READING BOROUGH COUNCIL

PLANNING APPLICATIONS COMMITTEE: 18 July 2018

App No: 180849/OUT

Address: Land Adjacent Thorpe House, Colliers Way, Reading

- Project CPCW
- Dwg No/rev SK-101E
- Scale 1:500@A3
- Date MAR 2018
- Checked by AC

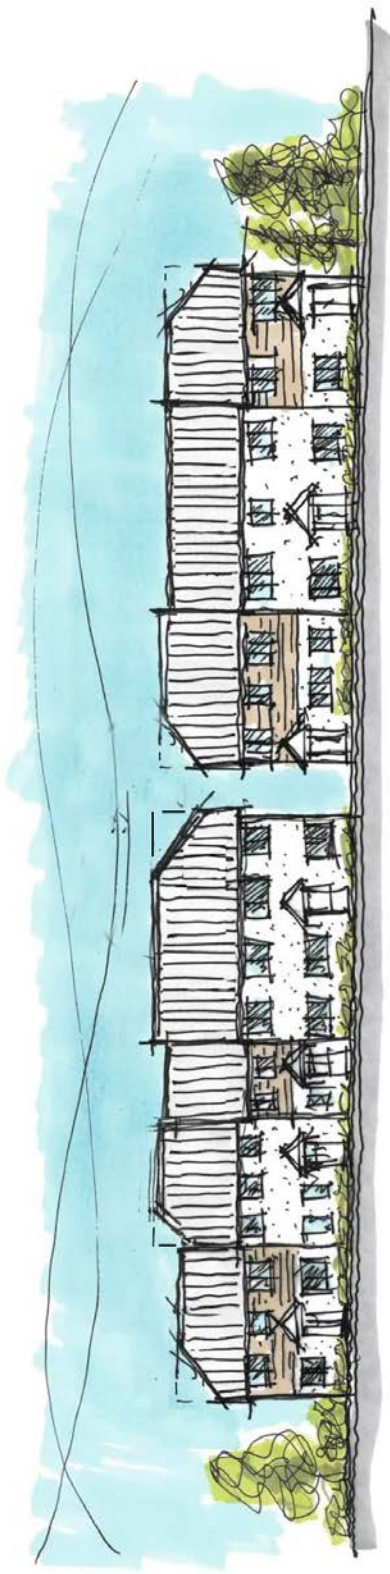
- 4.10 The driveway access to the rear of the parking bays has been illustrated at 7.5m in width which is in excess of the 6m forecourt depth required to accommodate access and egress to the parking bays themselves. This is also well in excess of the 4.8m width specified within Manual for Streets to accommodate a car passing a larger vehicle.

- 4.11 The tracking diagrams also appear to suggest a realignment of the kerb edge on the Western side of Kirton Close, however this will impact on the parking areas for 11-17 Kirton Close which does not appear to have been assessed. It would also need to be assessed whether any realigned road layout would be able to accommodate the turning of a delivery vehicle, although it is appreciated that a new turning area is proposed within the site this would be on non-adopted land and therefore a turning area must be retained.

- 4.19 The site plan labels 'Replacement Specimen trees' in the north corner of the site without making reference to the proposed removal of these two TPO trees (T1 & T2 of TPO) and refers to 'crown reduction existing TPO trees' with reference to two off-site trees in the Waverley Road gardens, neither of which are included in the TPO. The site plan should include clear, accurate information.

- 4.20 The AMS refers to Site Plan Rev D when Rev E has now been submitted. Having compared the two plans, there appears to be little difference so from an arboricultural point of view the change is not significant. The AMS recommends the removal of T1 & T2 on arboricultural grounds but confirms that neither require removal to implement the proposals as shown. However the previously submitted AIA (under 171219/OUT) (starting on Page 23 of the AMS) states that (5.2) 'Trees T1 and T2 may require removal to facilitate any new construction to the south of the existing footprint as it would prove problematic to avoid the suggested root protection areas'. Following receipt of the AIA last year, T1 (T540) & T2 (T541) were assessed and it was agreed that it would be reasonable to remove T2 due to its poor condition, but that T1 should remain. As the removal of T1 is not necessary in order to implement the scheme as shown, it is considered that its removal is not justified and it would be inappropriate to grant permission for its removal.
